Docket # 52-029 & 52-030
Levy LCOA

Problems With Nuclear Plants Addressed:

**Docket 52-029 & 52-030
Levy LCOA**

THE LEVY COUNTY AQUIFER VULNERABILITY ASSESSMENT

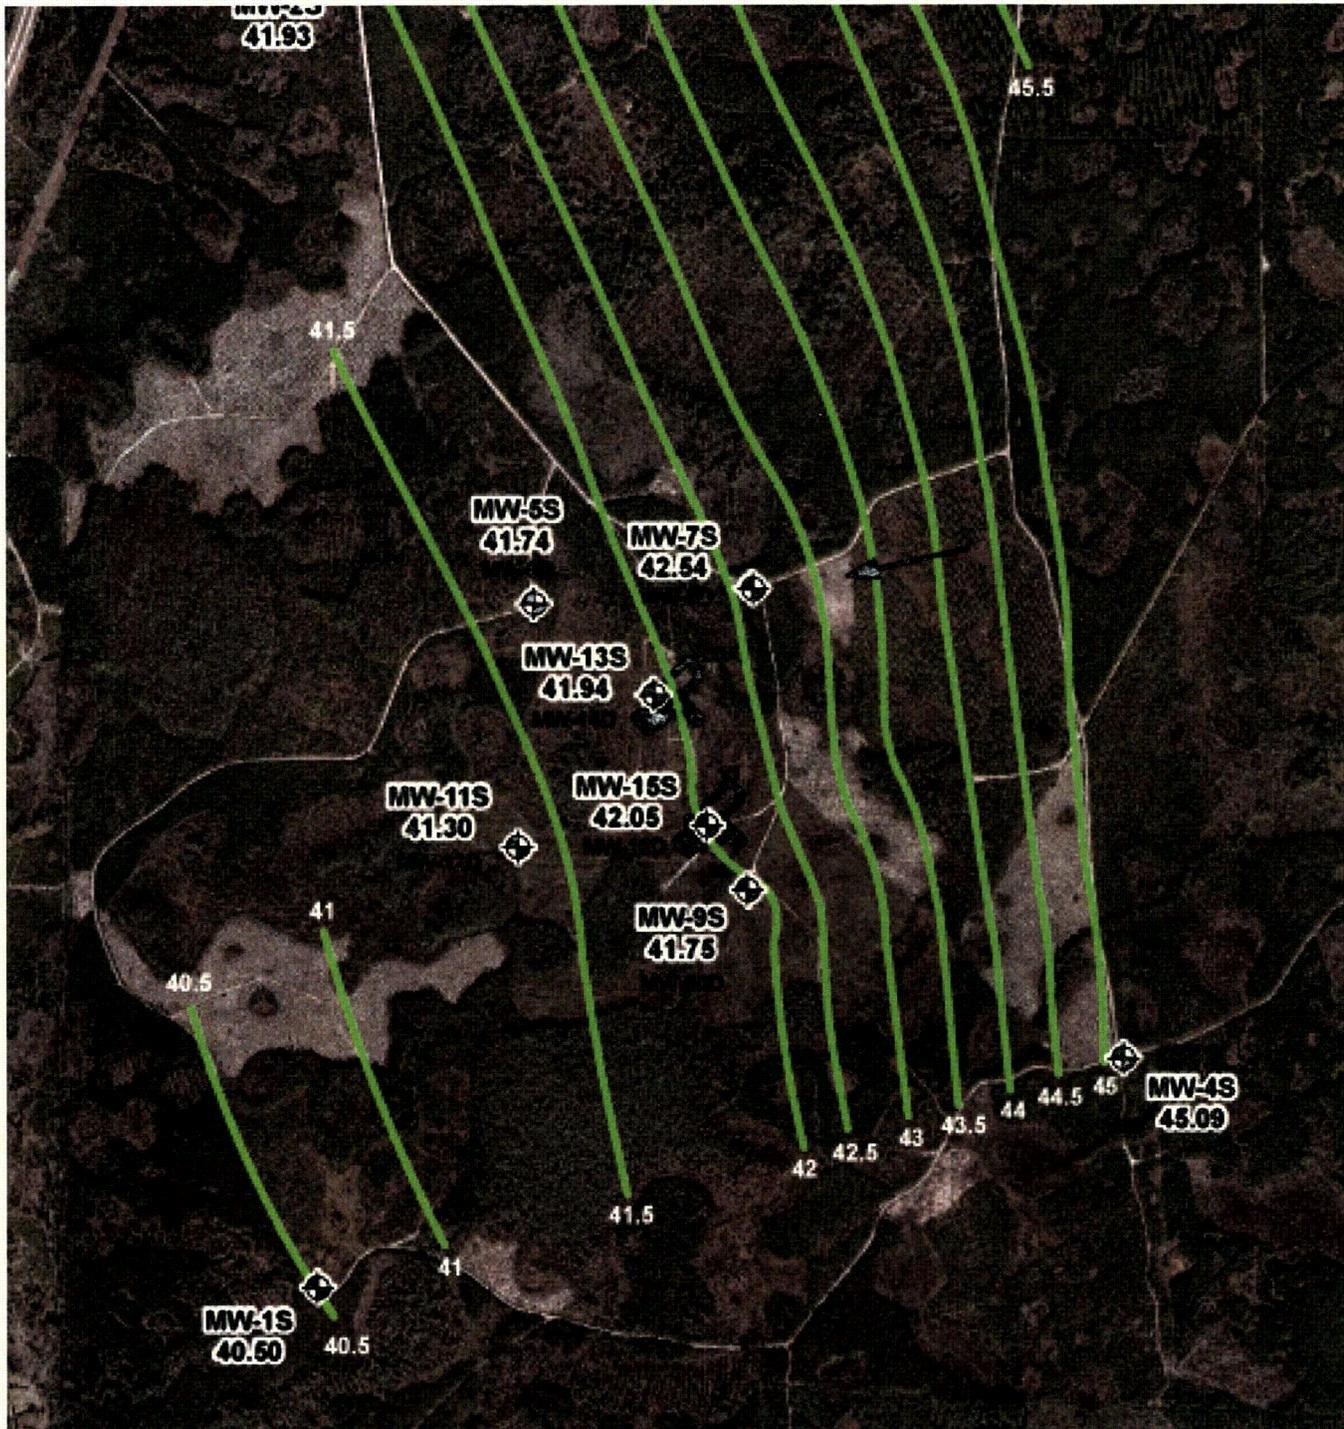
* COWCREEK - Flows to Waccassassa
 and Ten mile Flows into Cow Creek
 Tenmile is just to the East of the LNP 1:2
 It is missing from many maps - and this Flows North

Progress Energy Florida
**Levy Nuclear Plant
 Units 1 and 2
 Part 3, Environmental Report**

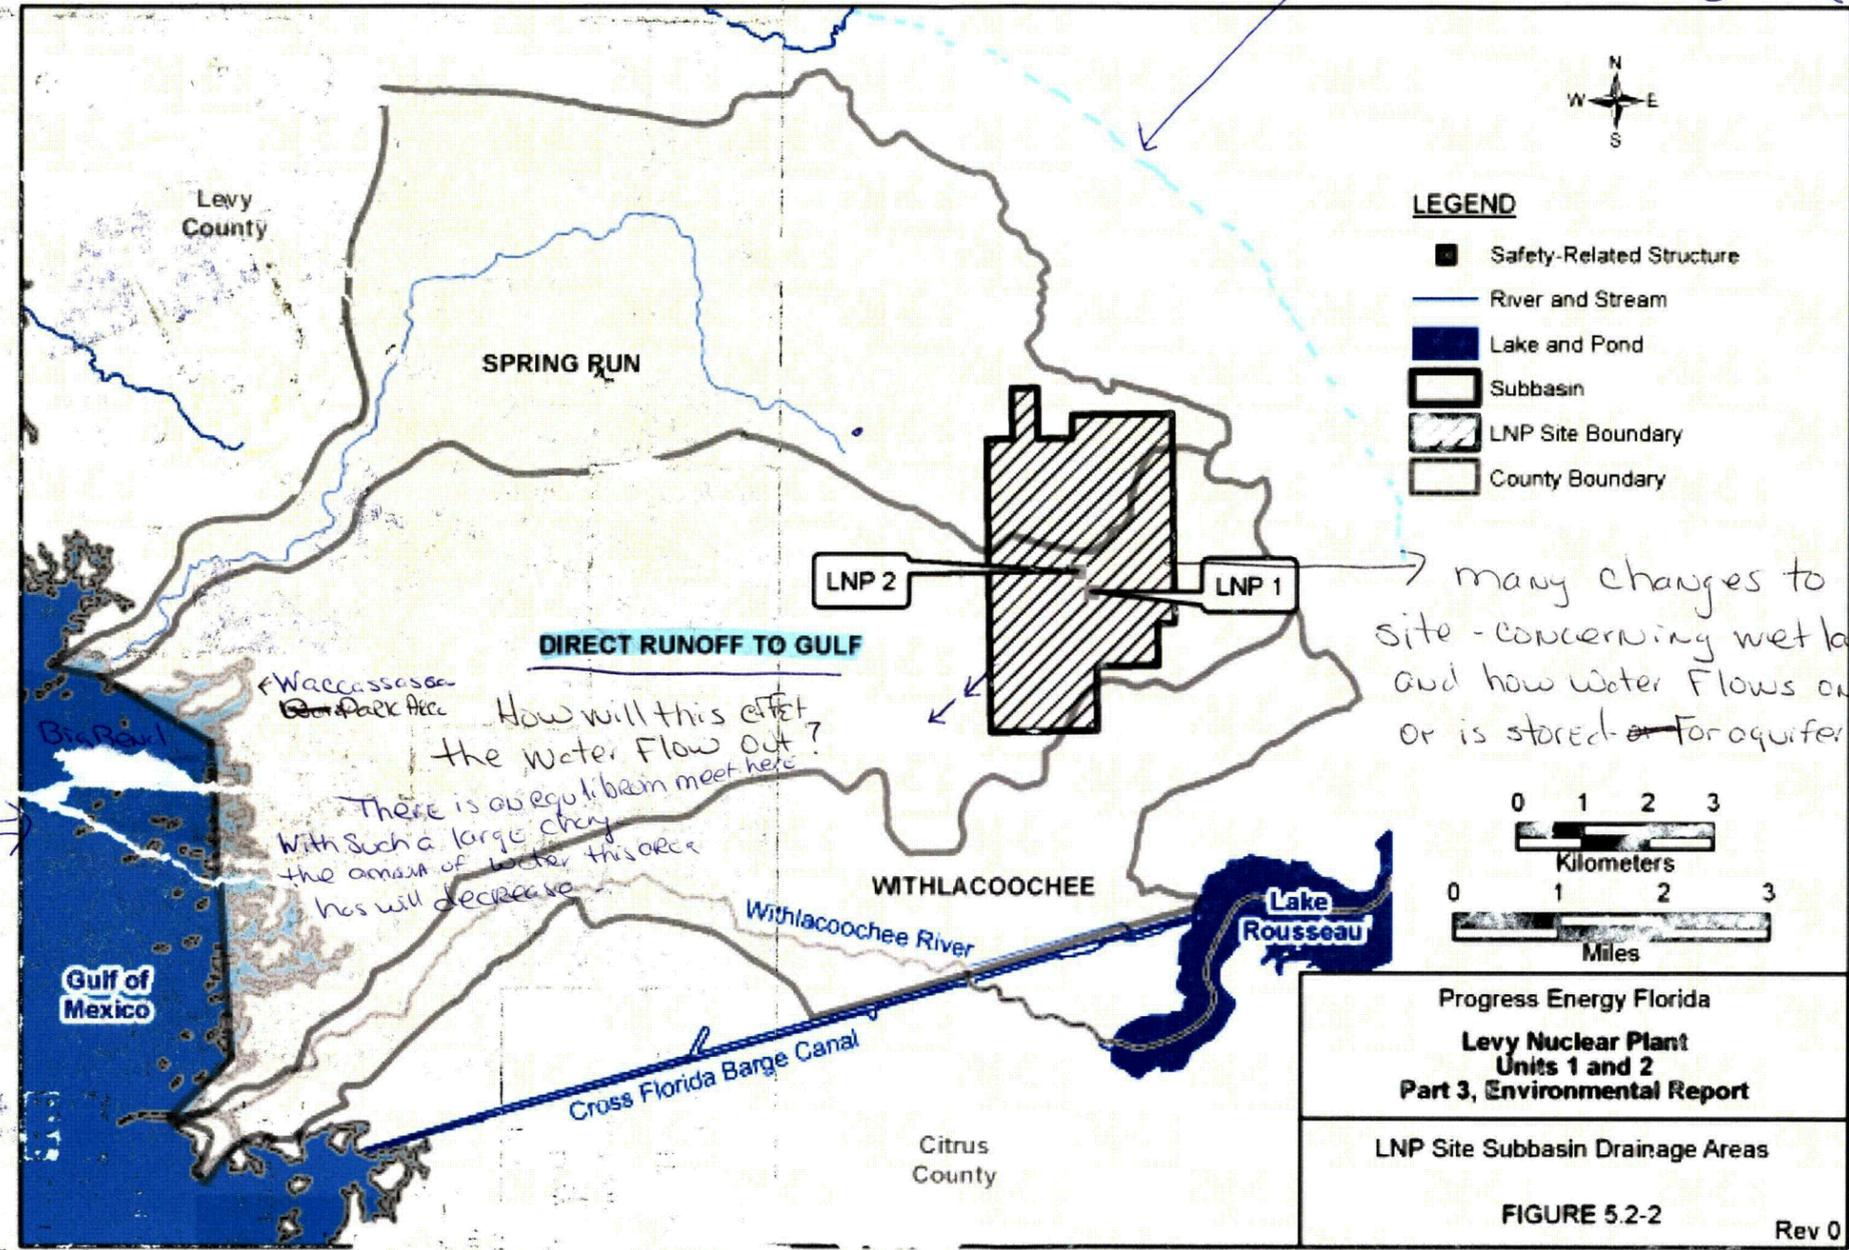
Estuary For Many Species
Such as Manatee
Turtles, lots of Fish.

approximate location
of Ten Mile - which
Feeds Cow Creek -
so this flows
North -
Cow Creek Feeds
into the Waccassassa
River - There is
Already a Problem
with Salt Water
and the MFL has
been set
is not helpful when this water
is not available any more?

How will this affect
the water flow out?
There is an equilibrium meet here
With such a large change
the amount of water this area
has will decrease

many changes to
site - concerning wet lands
and how water flows on land
or is stored for aquifer use

Many species from the South
say they must travel up to this area to
follow the fish, because the waters are
warmer than the waters in the South so the
fish are moving North - That is totally setting the Southern Ecosystems off balance -
what will happen with even more
WARM WATER.

Figure 14. Relative vulnerability map for the Levy County Aquifer Vulnerability Assessment project. Classes of vulnerability are based on calculated favorability of a unit area containing a training to flow point, or a monitor well with water quality sample results indicative of vulnerability.

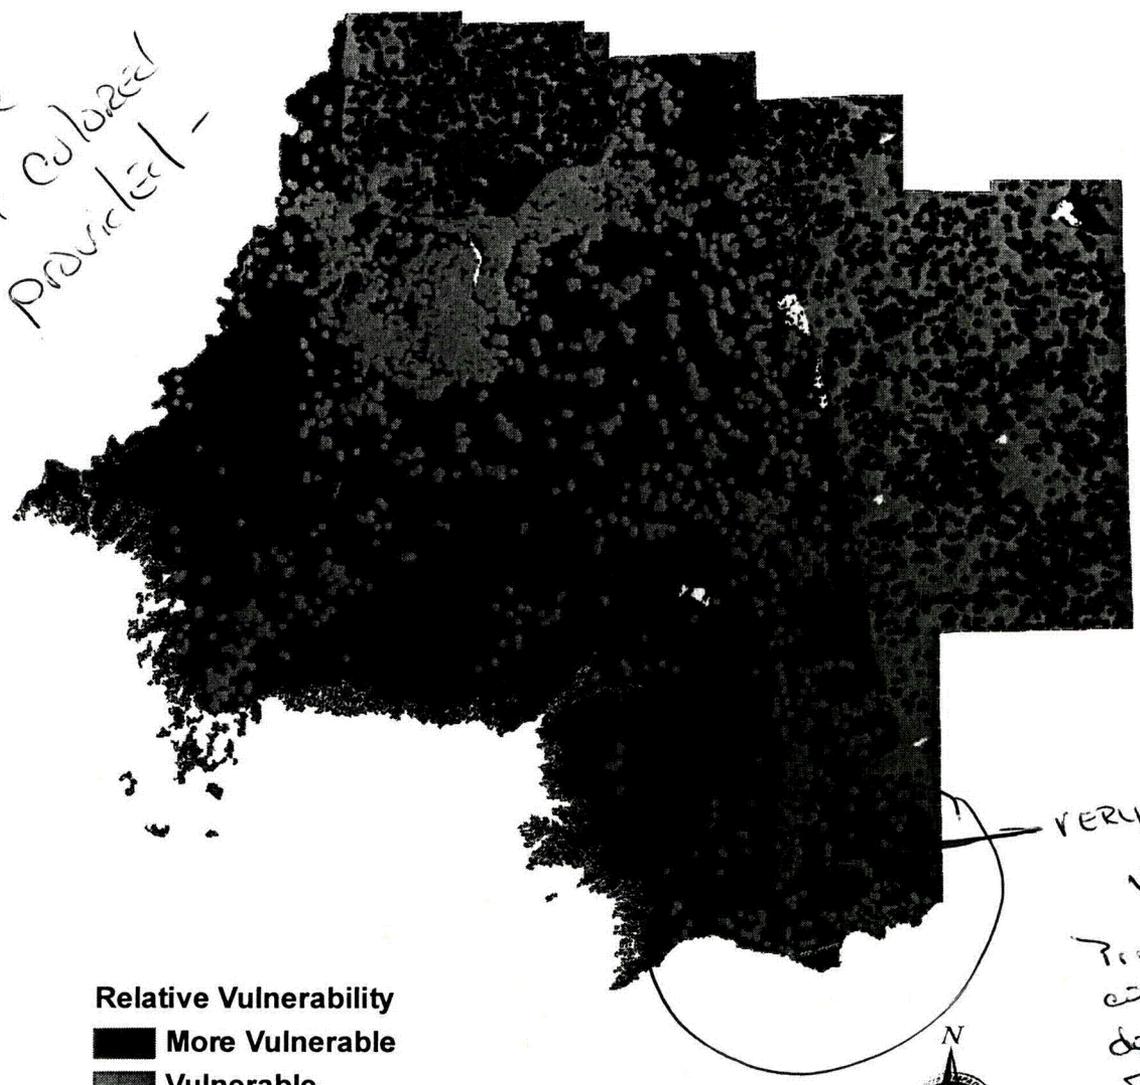
Please
look at colored
map provided -
